PLAN UPDATES FOR POWER BOATS UNDER 16'

CONTENTS

Optional angled transom.

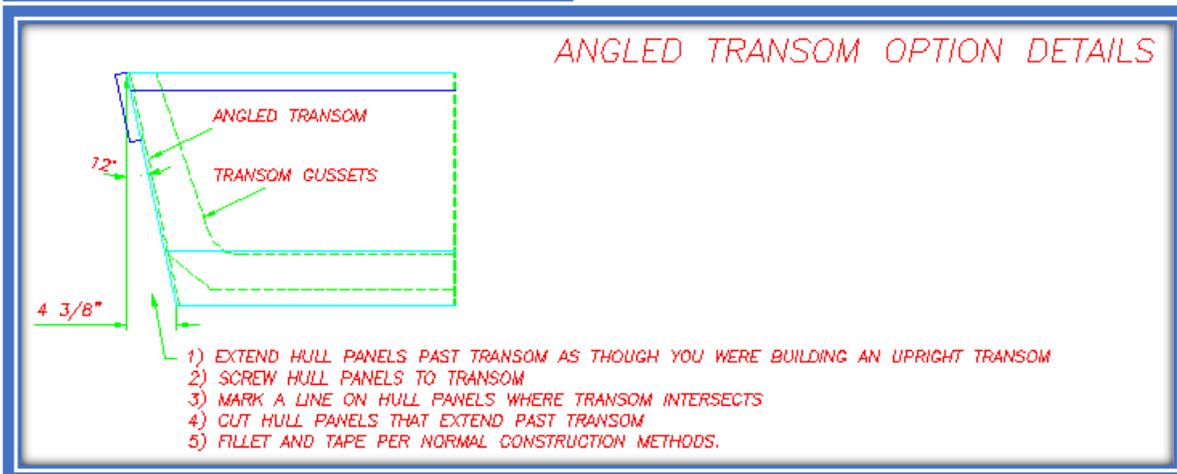
Some people have asked for an angled transom option for the GV11 - here are the revised transom and transom gusset dimensions.

OB15 DIMENSIONS

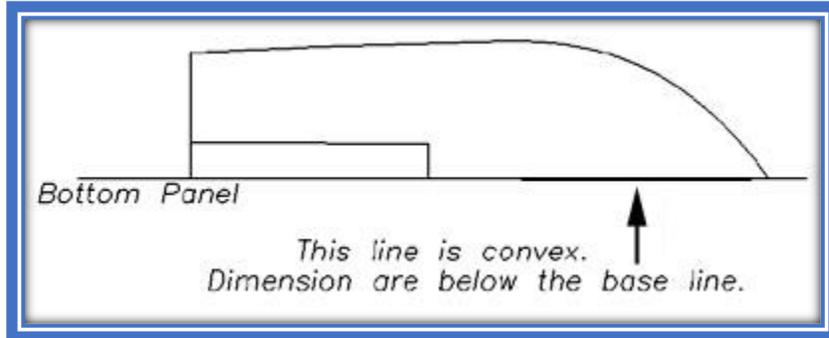
Revision after 15 years. One of our builders brought the following to our attention:

-  A small kink in the side panel
-  A wrong location for the motorwell bulkhead

Most builders will not notice any problem. They will fair the small kink with the batten and if they use the motorwell sides on the jig, as we state in the building notes, they will not need that location. That is probably why we never heard of the dimension's mistakes. However, the plans must be correct and here are the revisions.

-  on drawing D107/6, side panel dimensions, the last one towards the bow before the tip should be 5" (126 mm), not 5-3/8"
-  on drawing D107/5, motorwell location, distance from the transom is 20" (510 mm) not 2' 2". Note that that distance is given again on D107/3 and there it was correct. And again, try not to use that dimension, use the motorwell sides as we write in the building notes. You can't go wrong that way.
